October 2022
FL952A
NHTSA #22V-681
Transport Canada #2022-513

Subject: Western Star 47X and 49X Steering Pinch Bolt

Models Affected: Specific model years 2022-2023 Western Star 47X and 49X model vehicles manufactured October 8, 2021, through August 10, 2022.

Fig. 1, I-shaft Installed Properly

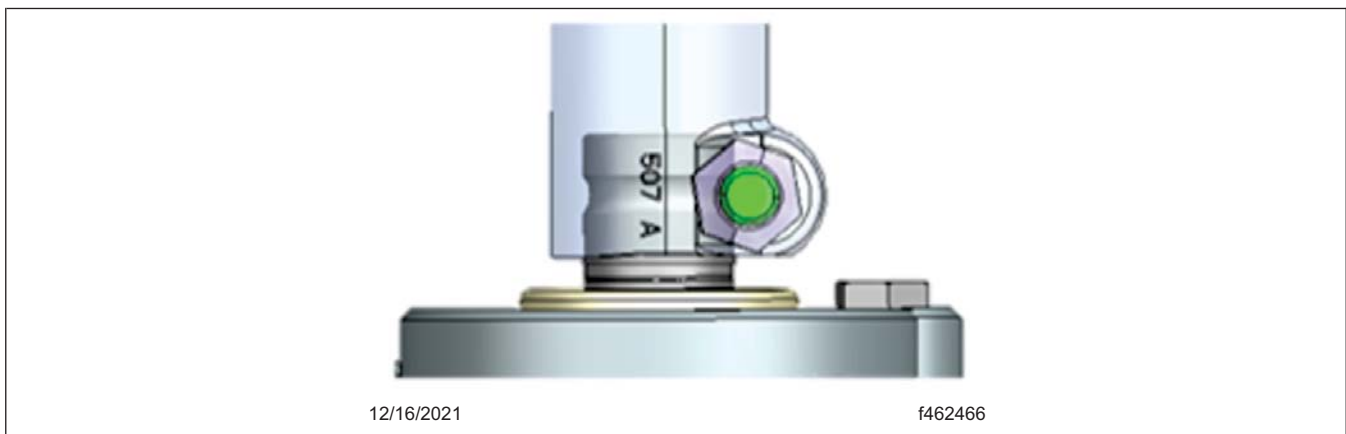
1. Check the base label (Form WAR259) for a completion sticker for FL952 (Form WAR260) indicating this work has been completed. The base label is usually located on the passenger-side door, about 12 inches (30 cm) below the door latch. If a completion sticker is present, no work is needed. If a completion sticker is not present, go to the next step.
2. Park the vehicle on a level surface with the front tires pointed straight ahead. Shut down the engine, set the parking brake, and chock the tires.
3. Open the hood.
4. With the truck running, turn the wheel so the pinch bolt is accessible at the top of the steering shaft.
5. Inspect the I-shaft to ensure it is seated all the way down to the steering gear. For correct installation, see [Fig. 1](#). For incorrect installation, see [Fig. 2](#).

If installed properly, no further action is required. Proceed to step 6.

Fig. 2, I-shaft is Lifted or Displaced

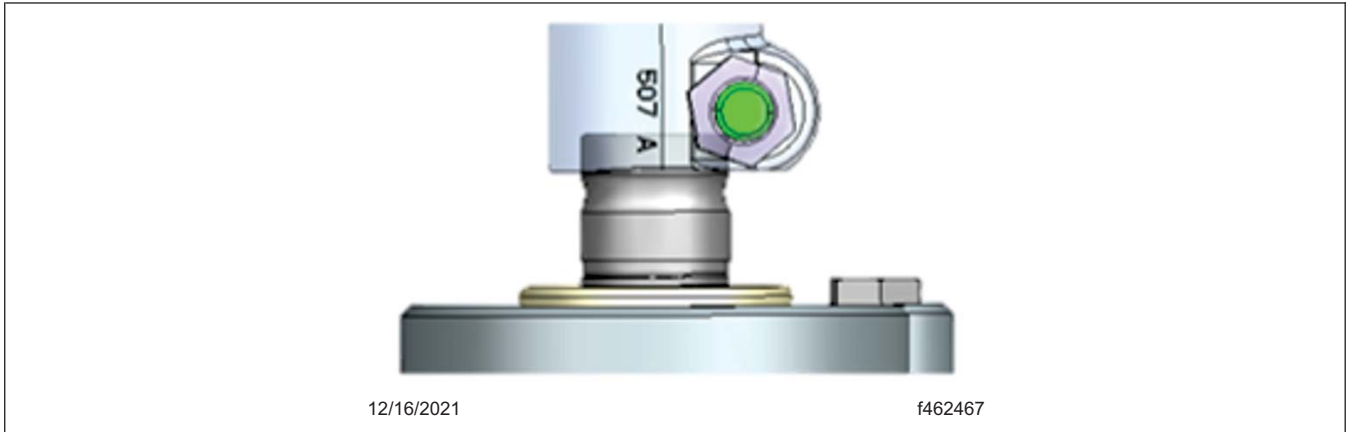
If lifted and not seated correctly, go to the **Pinch Bolt Replacement** procedure below.

NOTICE: Do not remove the steering shaft from the steering gear; it is only necessary to slide it the rest of the way on the steering gear until seated completely. Removal of the I-shaft could result in the steering wheel being rotated and damaging the clock spring. Once the shaft is seated and the new pinch bolt is installed, torque the nut on the pinch bolt until required torque is achieved.

1. Remove and discard the pinch bolt and nut on the gearside of the I-shaft.
2. Slide the steering shaft down so it is flush with the steering gear.
3. Install the new pinch bolt and nut.
4. Tighten the pinch bolt 30 to 35 lbf·ft (41 to 47 N·m).
5. Use blue torque seal after the required torque has been set.
6. Clean a spot on the base label (Form WAR259), write the recall number, FL952, on a blank red completion sticker (Form WAR260), and attach it to the base label, indicating this work has been completed.
